# COUNTY SANITATION DISTRICTS OF LOS ANGELES COUNTY

October 10, 2014  
File No. 21-17.01-55

**Comments on Tentative Waste Discharge Requirements (WDRs) and National  
Pollutant Discharge Elimination System (NPDES) Permit for the  
Pomona Water Reclamation Plant (NPDES Permit No. CA0053619, CI No. 0755)**

**Figure 1. Dose-response pattern depicting a likely false negative error.**

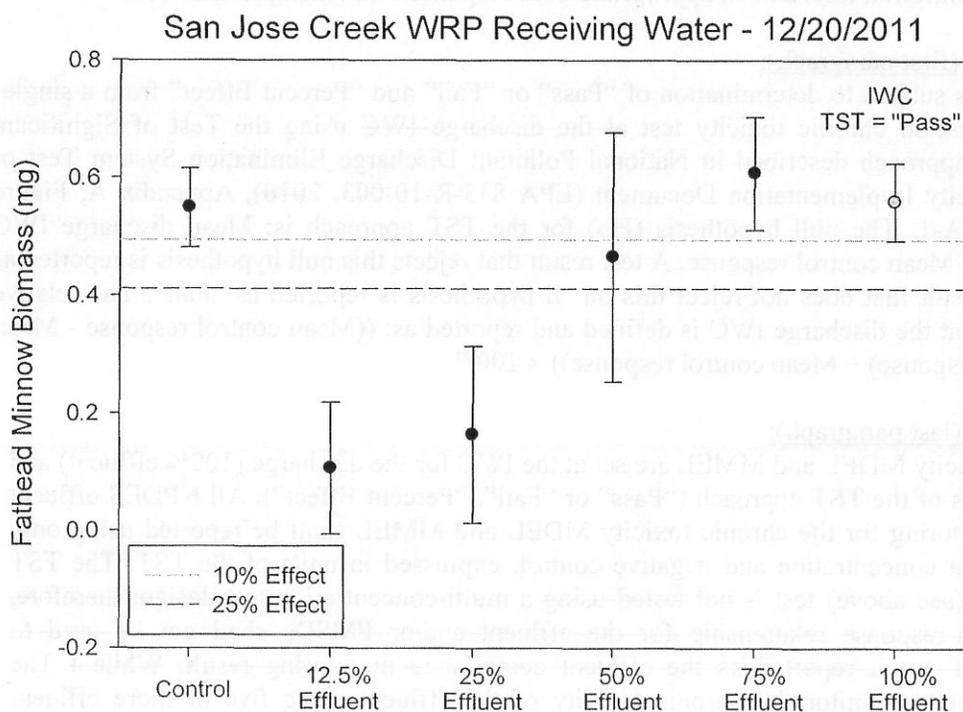
Conducting multiple concentration WET tests and evaluating the dose-response relationship is one of the more critical and significant method-defined procedures for addressing this variability and validating data. The concept of a dose-response/concentration-response relationship has been described by toxicologists as “the most fundamental and pervasive one in toxicology”<sup>2</sup>. This concept assumes that a causal relationship exists between the concentration of a pollutant in a sample and the measured organism response. In other words, it is assumed that increasing organism response or effect is due to increasing pollutant/toxicant concentrations. Evaluation of the dose-response relationship provides the empirical evidence that supports this assumption. Therefore, evaluating dose response information is critical to associating any observed response to “toxicity”. If an effect is caused by “toxicity”, higher concentrations should logically exhibit the same or greater effects and lower concentrations should exhibit the same or lower effects. The only way this can be evaluated is by conducting multiple concentrations. Anomalies in this expected or assumed dose-response curve reduces confidence in the test’s ability to accurately estimate “toxicity” or, more specifically, the test’s ability to estimate effects associated with pollutants or toxicants. In fact, the USEPA determined that application of a relatively simple dose-response evaluation procedure reduced the false positive rate among non-toxic blank samples from over 14% to less than 5%<sup>3</sup>. Although more challenging to quantify, evaluation of the dose-response relationship is also expected to significantly reduce the false negative error rate as well (see example below).

In the absence of multi-concentration testing and a dose-response evaluation, the results depicted above would have been identified as an unqualified “Pass” using the USEPA Test of Significant Toxicity

(TST) protocol. However, pending the findings of additional data evaluations, this test that otherwise would have been declared “non-toxic” or “Pass”, will likely be identified as “inconclusive” and repeated after conducting a dose-response relationship evaluation.

Therefore, we request that the following changes be made to the Tentative Permit to accurately reflect allowable and required 40 CFR Part 136 protocol evaluation procedures that include the ability conduct multiple concentration tests and an appropriate dose response relationship evaluation.
